Product Management – Coal Mining Industry

Notification IN00016 Rev1 July 2023

VSDguard, ELV-PRO and ELV-PRO RV: Latching trip contacts in AC control circuits

Figure 1: Open Contact Filter Current Path at 110 VAC.

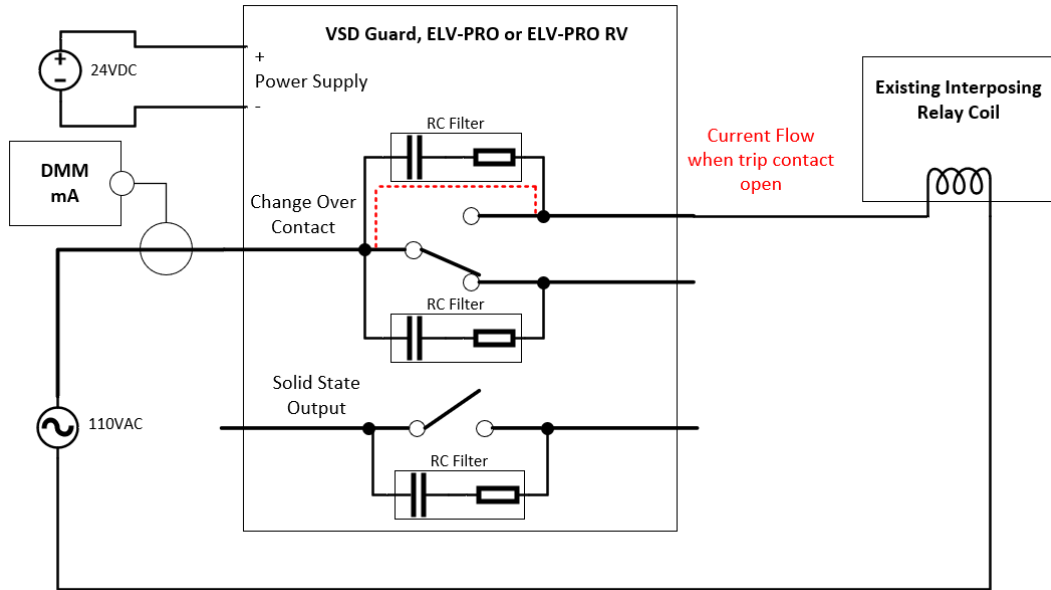
Refer to Figure 1.

When used with a 110 VAC control supply, the internal transient suppression filter (RC combination, $22\Omega + 100\text{nF}$) across the trip contact terminals can allow up to 4.5mA of current to be sustained after the trip contacts open. This current is sufficient for OEM interposing relays with low VA ratings to hold in.

The possibility of latching is dependent on the relay coil impedance and relay's magnetic circuit, and so no specific holding current can be nominated for all installations.

Note that when a DC control supply is used (e.g. 24 VDC) then no issue is encountered as the capacitor blocks DC current.

Figure 2: Use of the EL test function to assess vulnerability of the installation.

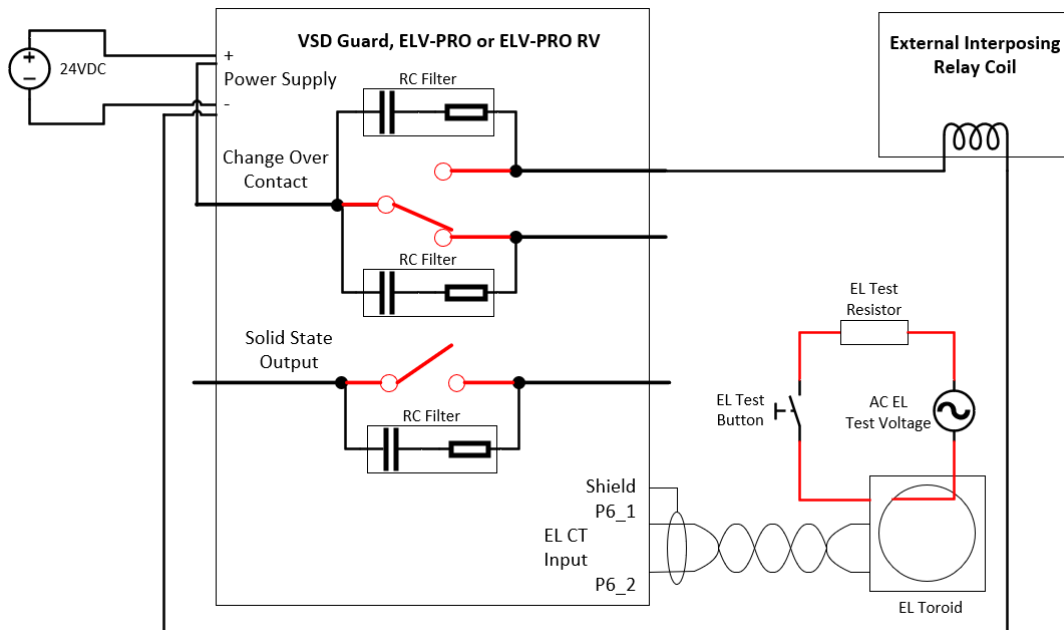
1. The vulnerability of an individual installation can be assessed via the routine Earth Leakage (EL) test function. See Figure 2. Repeated operation of the EL test will verify that the relay contacts open as intended, or whether they have a vulnerability to stay closed. Multiple operations are recommended to give a statistical reliability.

Note that during testing, the physical opening of the interposing circuit should be verified: PLC indication feedback alone does not provide adequate test coverage.

Figure 3: Use of higher VA rated relay coil circumvent vulnerability.

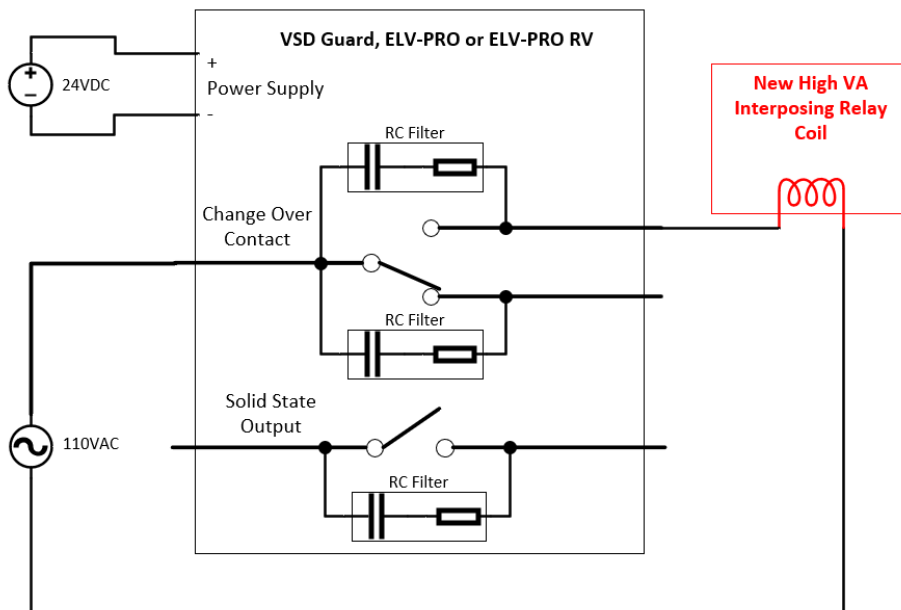
1. Change out the low VA rated relay coil for a higher VA rated relay coil such as those listed in the first **two rows** of Table 1. See Figure 3.
2. Change out the 110 VAC control supply for a DC control supply such as 24 VDC. See Figure 4. The DC current will be blocked by the capacitor in the transient suppression filter regardless of which relay is used.
3. Introduce a new DC interposing relay so isolate the existing AC circuit from the relay contacts. See Figure 5. Note however that this approach will increase tripping times due to the sequential relay logic. The increased tripping time increases the touch potential hazard due to extended exposure times.
4. Return the affected Ampcontrol product to Ampcontrol for removal of the Transient Suppression filter components. Note that this will become a standard repair procedure into the future.
